Toyota Integration Relay Failure

Integration Relay Failure Caused From Service Repair Model: Camry ASV50, AVV50 Aurion GSV50

This Technical service bulletin is to advise you of the fault, cause, remedy and counter measure for the potential failure of the integration relay.

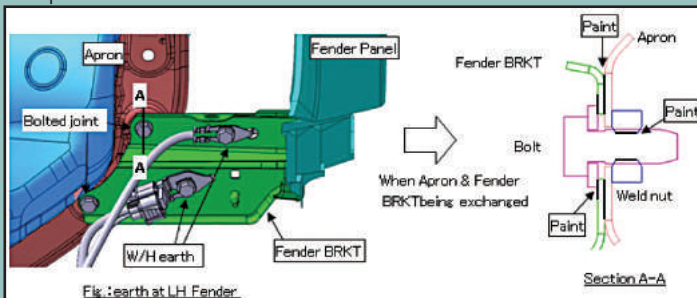
Investigations initially found the integration relay had over heated and failed. Further investigations traced the cause of the overheating to a poor earth point to the integration relay. This poor earth was caused by paint between the fender bracket and apron, after body repairs had been carried out. Ref picture below.

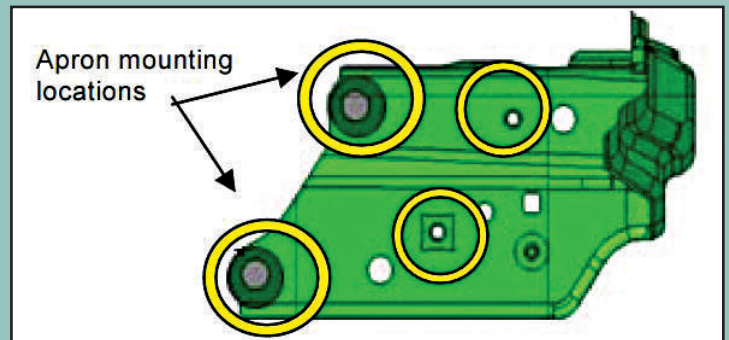
Remove the apron and inspect mounting locations both front and back. The mounting areas should be free of paint, tape etc. The mounting areas should be bare metal.

The back of the bracket has captive nuts, ensure the threads in the nuts are free of paint.

Ensure that the bracket surfaces where the earth bolt and washer make contact are cleaned back to bare metal to achieve a proper earth.

Circled areas are the critical bolt mounting areas. (see illustration top of next column)
